Origination Form
Proposed Revisions to a Standard Plans Index

Originator:	Turley, Joshua	Index Number:	700-041
Date:	4/11/2024	Sheet Number(s):	2
E-mail:	Joshua.Turley@dot.state.fl.us	Index Title:	SPAN SIGN STRUCTURE

BASE PLATE CONNECTION

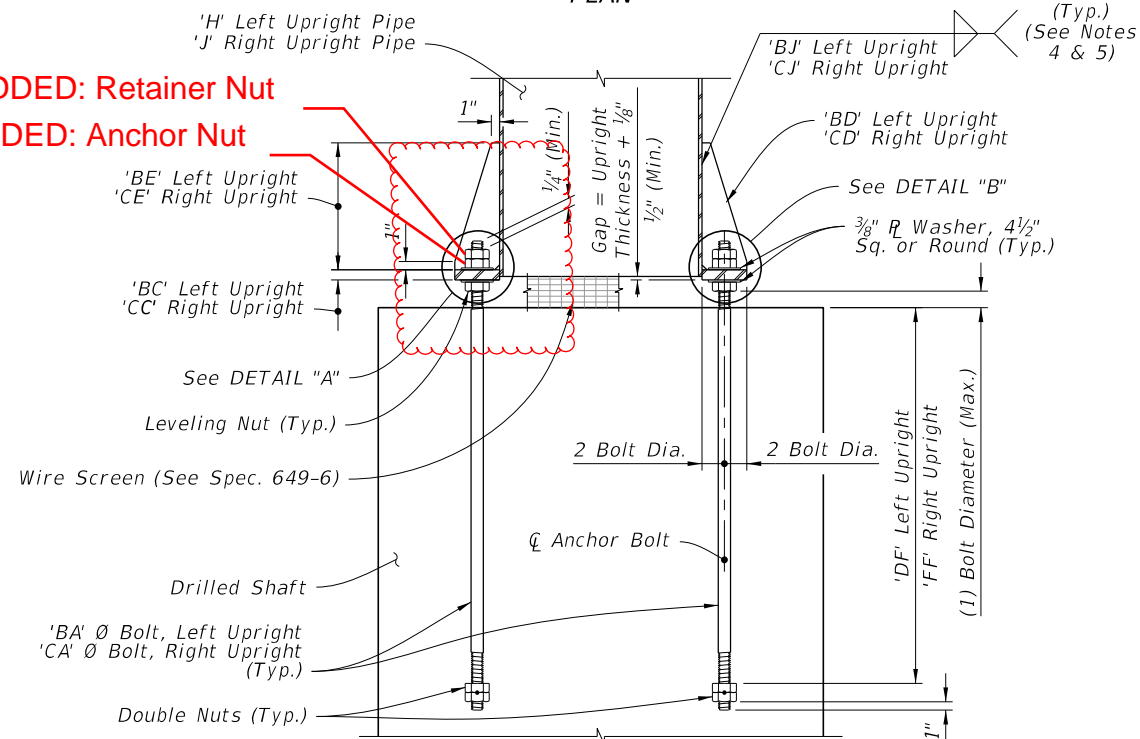
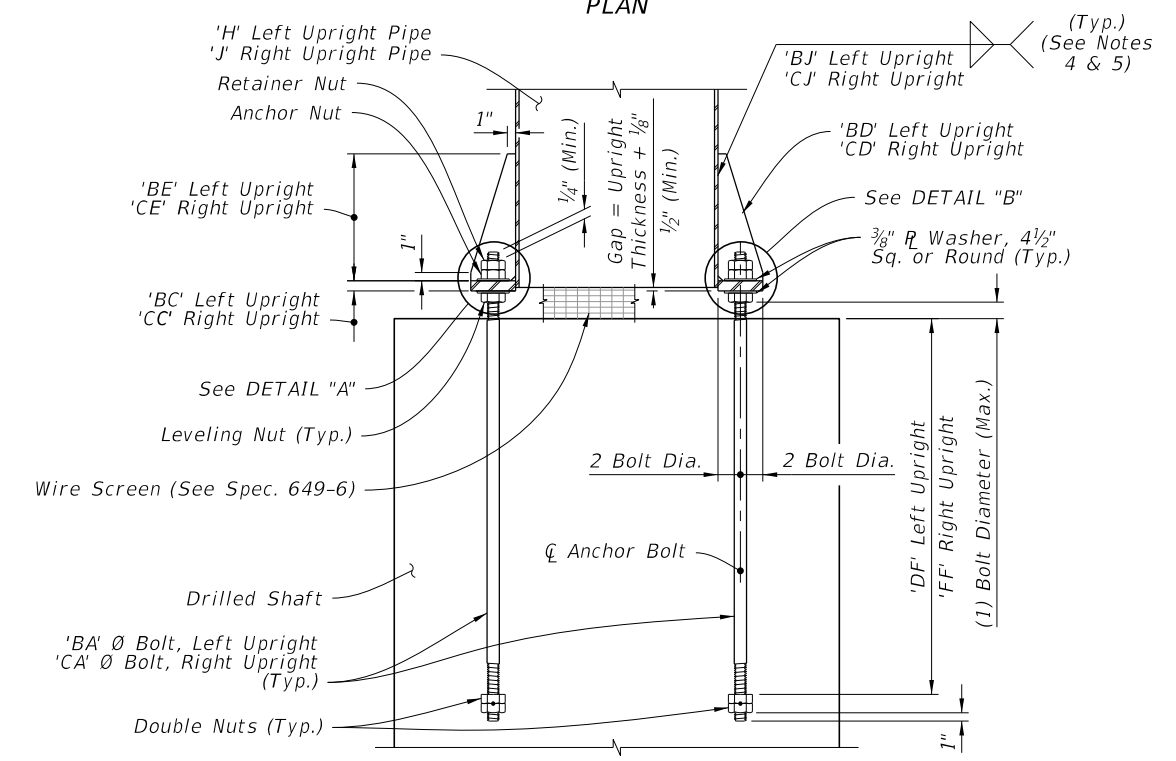
Sheet 2: Added labeling to the Anchor bolt nuts in BASE PLATE CONNECTION - ELEVATION

ADDED: Retainer Nut
ADDED: Anchor Nut

Labels were added to correspond correctly with upcoming spec change to Spec 649.
